Copied from the Tracey O'REILLY ADDITION
10/23/86

Re: S/D 96-61 O'REILLY ADDITION (Final Plat)

Re: S/D 96-61 O'REILLY ADDITION (Final Plat)

CASE NUMBER: S/D 96-61 - O'REILLY ADDITION

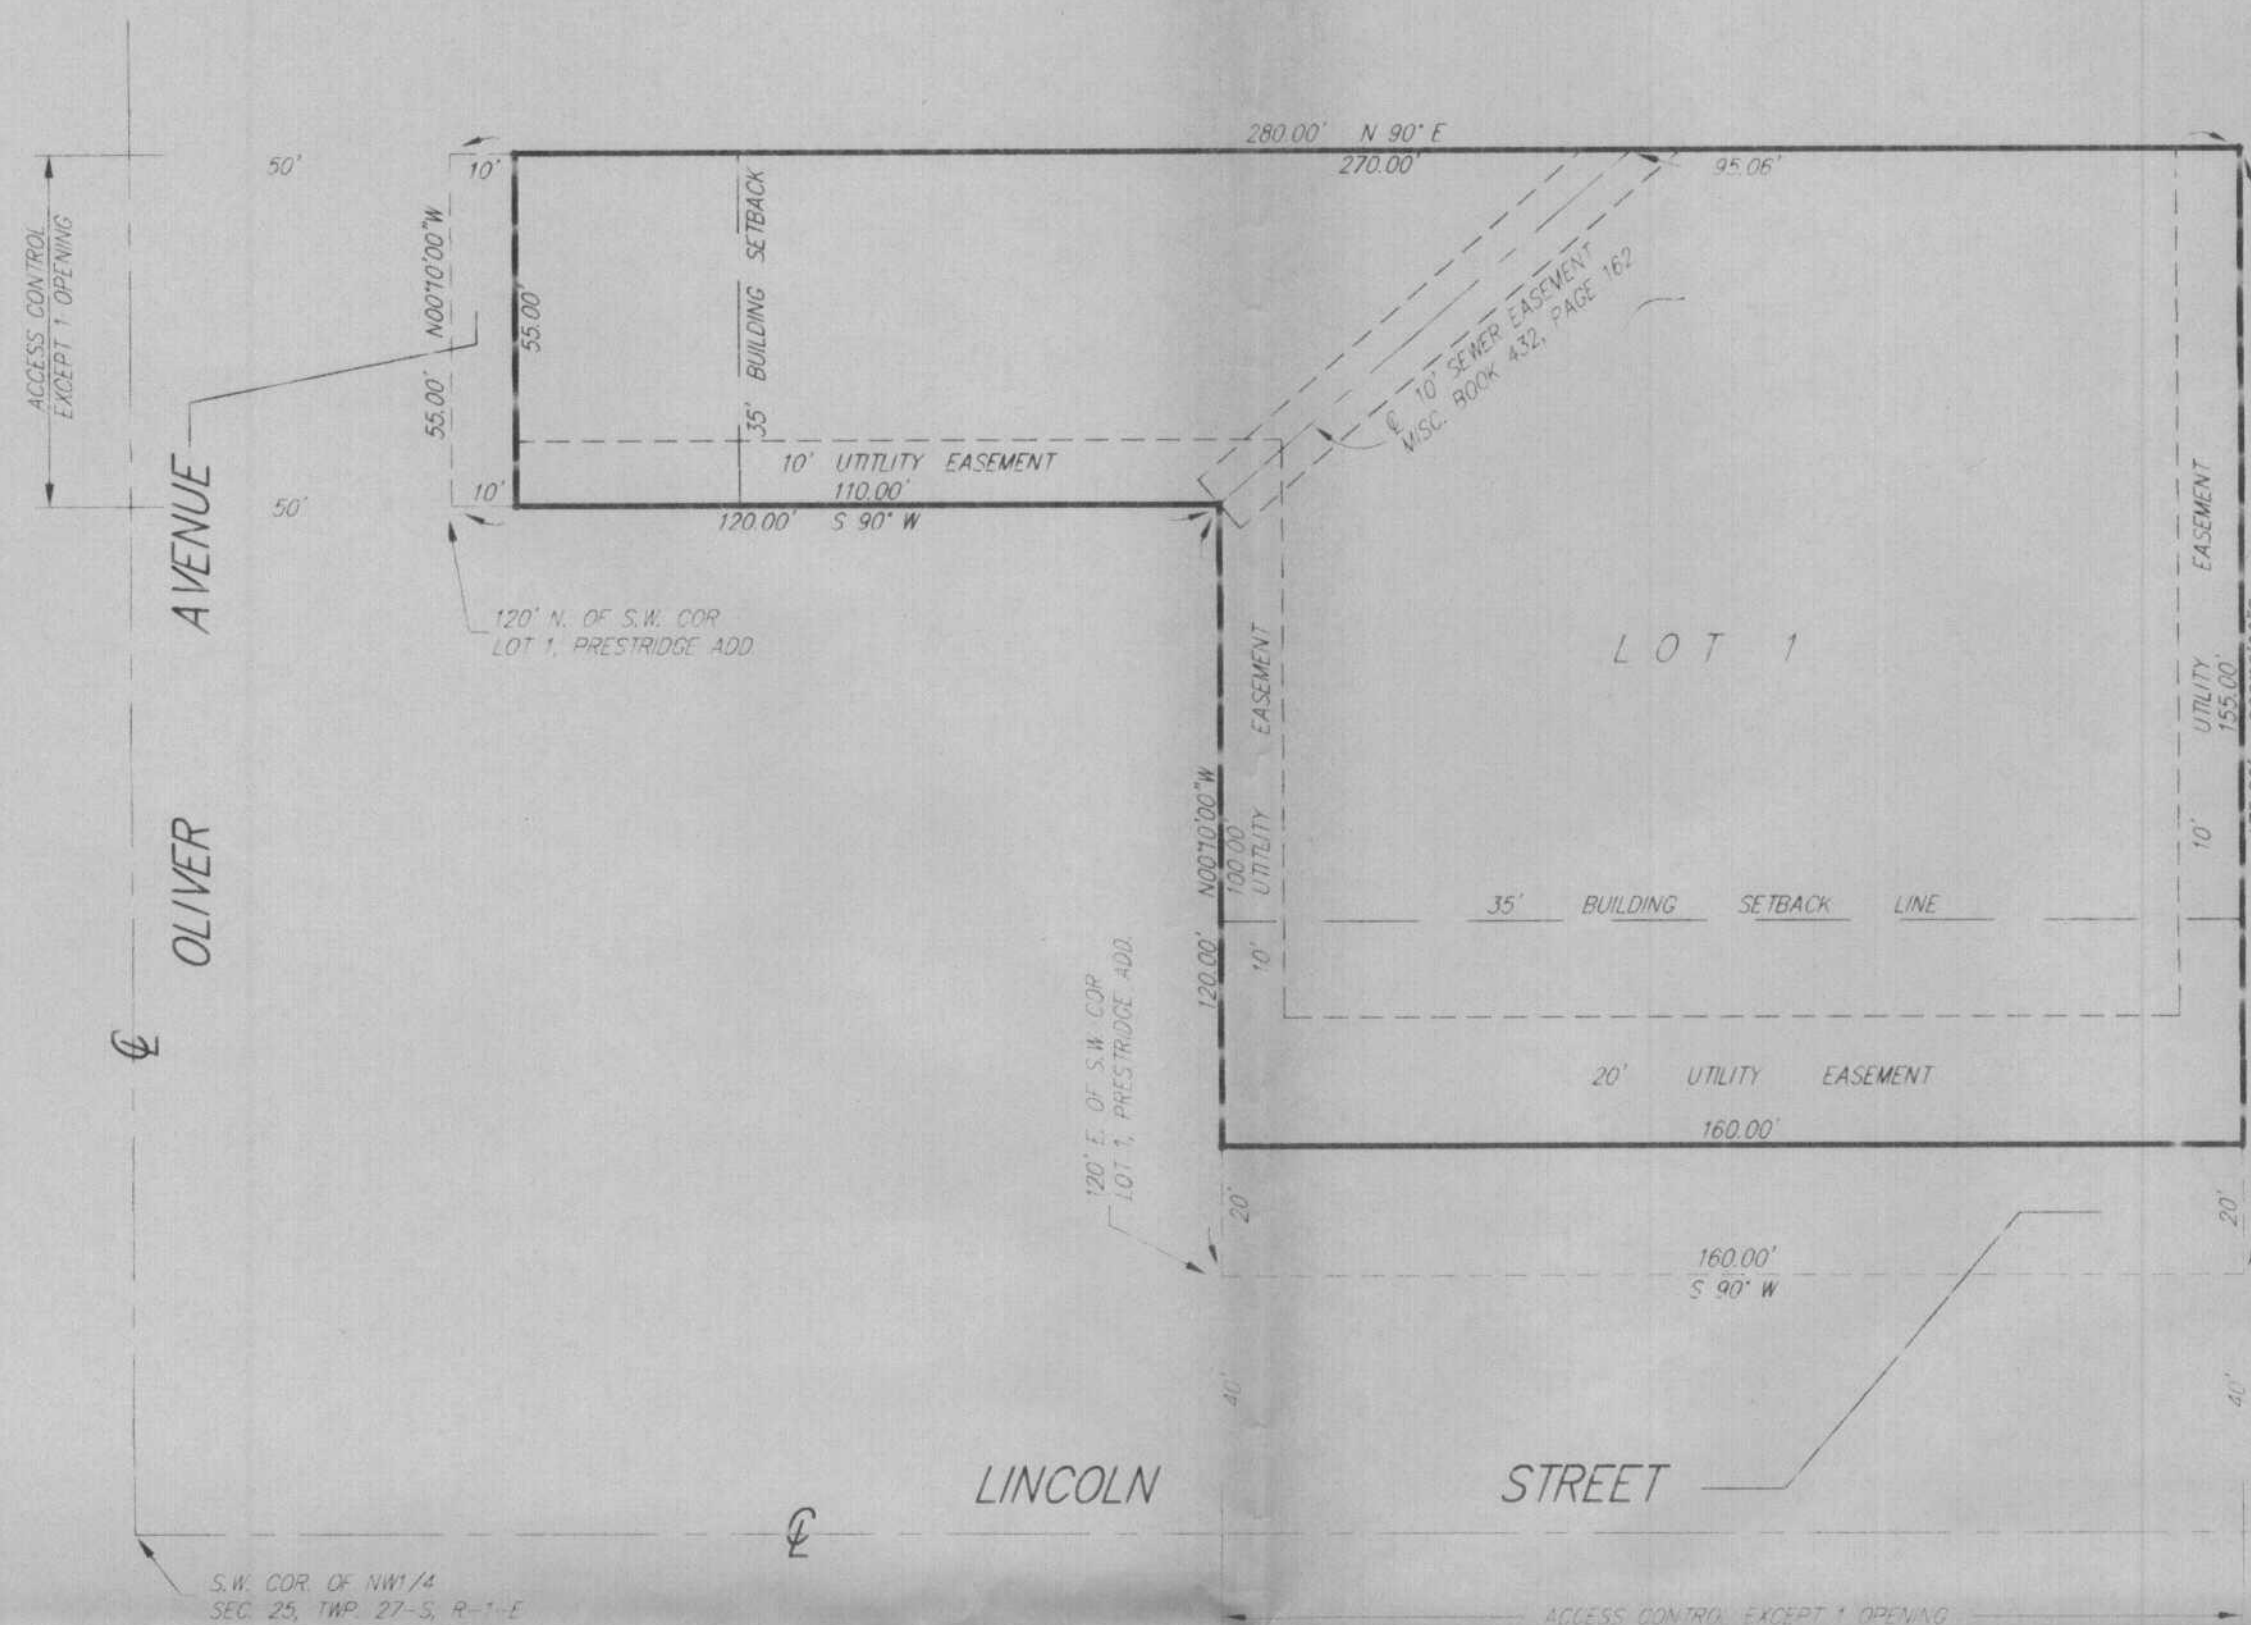
- ~~A.~~ The applicant shall guarantee any drainage improvements required by the platting of this property.
- ~~B.~~ *Approved along S line of plat*
An existing use (building) at the corner of Oliver and Lincoln is being surrounded by this plat. Sanitary sewer service is apparently being provided by a service line crossing abutting properties and covered by a ten (10) foot utility easement. A 20-foot public easement shall be provided at some location to allow for extension of a public sewer line to that site.

- ~~C.~~ Access control except for one opening shall be granted along Lincoln from this plat.
- ~~D.~~ Additional street right-of-way shall be dedicated rather than contingently dedicated.

- ~~E.~~ The applicant shall install or guarantee the installation of all utilities and facilities which are applicable and described in Article 8 of the MAPC Subdivision Regulations. (Water service and fire hydrants required by Article 8 for fire protection shall be as per the direction and approval of the Chief of the Fire Department.)

- ~~F.~~ The applicant's engineer is advised that the Register of Deeds is requiring the name(s) of the notary public, who acknowledges the signatures on this plat, to be printed beneath the notary's signature.

- ~~G.~~ Perimeter closure computations shall be submitted with the final plat tracing. Section 5-101(c).
